# GENERAL ELECTRIC

SUBJECT: SUMMARY OF AUGUST 5, 1980 NRC/GE MEETING ON CORE SPRAY  
DESIGN METHODOLOGY

BWR CORE SPRAY DESIGN

- SUPERPOSITION OF TESTS #16 & 17
- DOUBLE NOZZLE TEST #18

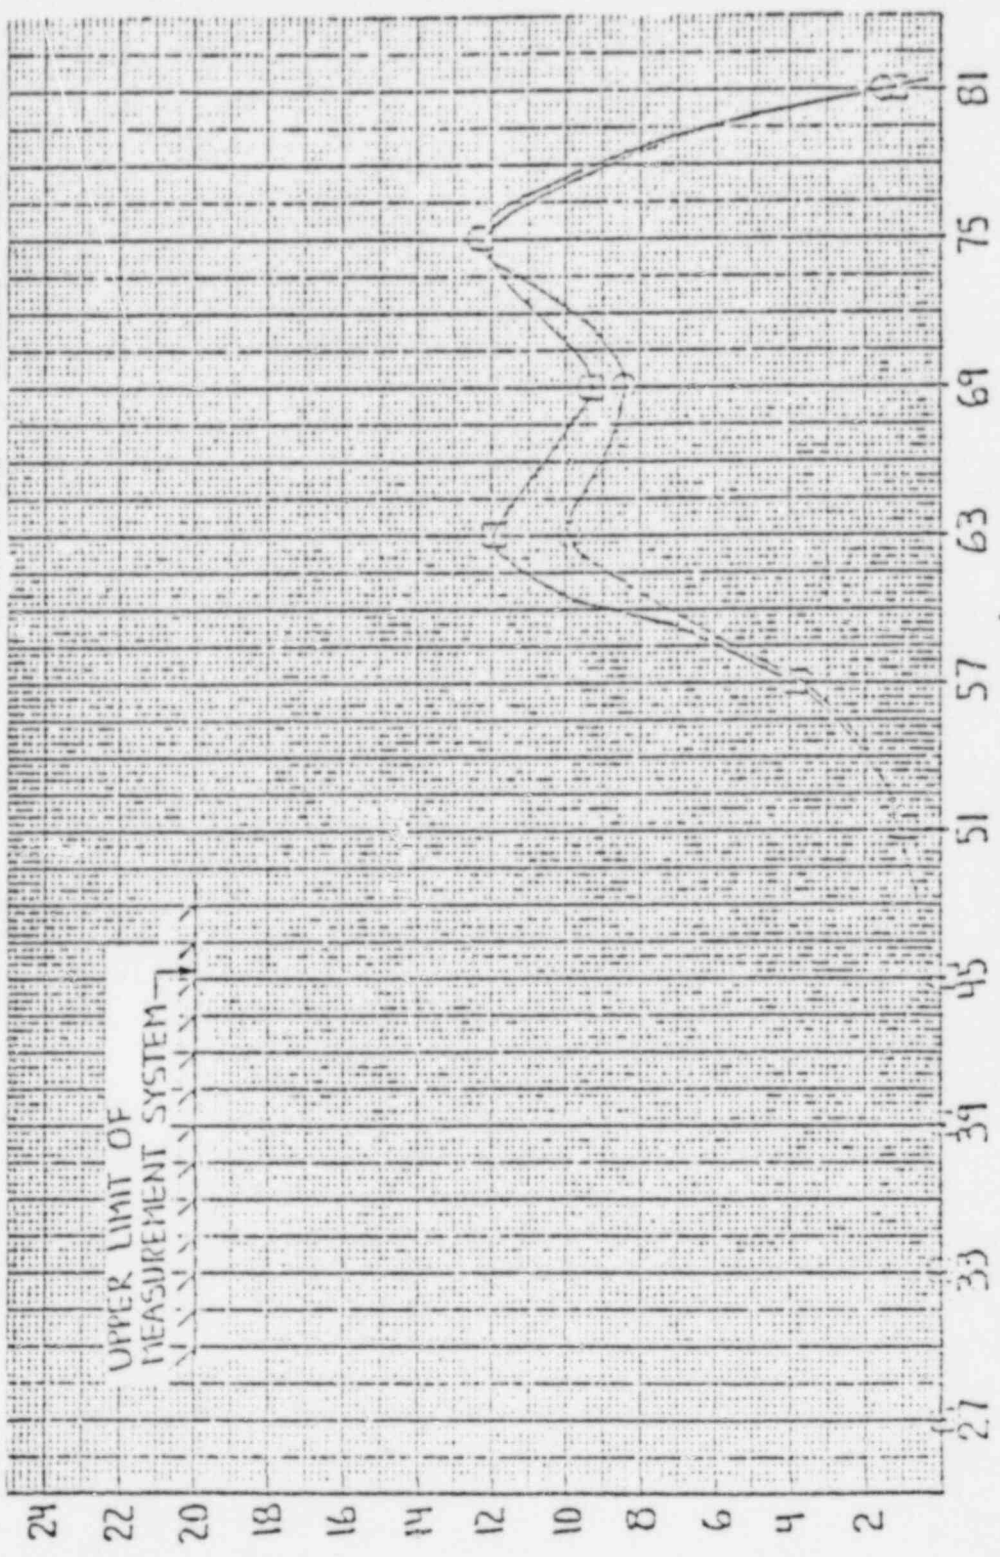
HOW CAN METHODOLOGY BE APPLIED TO BWR/4,5 DOUBLE  
HEADER OPERATION WHEN NOZZLES ARE CLOSE TOGETHER?

WHEN TWO NOZZLES INTERACT IN THE CONDENSING REGION  
CLOSE TO THE NOZZLES, THEY NEED TO BE TESTED TOGETHER IN  
STEAM AND TREATED AS A "SINGLE NOZZLE" FOR THE METHODOLOGY.  
SUCH NOZZLE-PAIR TESTS HAVE BEEN CONDUCTED FOR THE CLOSE VER-  
TICAL-SPACED NOZZLES OF THE BWR/4-5 DOUBLE HEADER. THE RE-  
SULTANT DISTRIBUTIONS SHOW VERY LITTLE EFFECT FROM CONDEN-  
SATION IN THE INTERACTION REGION, AND CONFIRM THAT THE  
METHODOLOGY CAN BE DIRECTLY APPLIED USING THE NOZZLE-PAIR  
APPROACH.

- o APPROPRIATE DESIGN OF SIMULATORS NEEDED
- o TREAT DOUBLE HEADER AS A PSEUDO SINGLE HEADER
- o REST OF METHODOLOGY USED AS FOR BWR/6
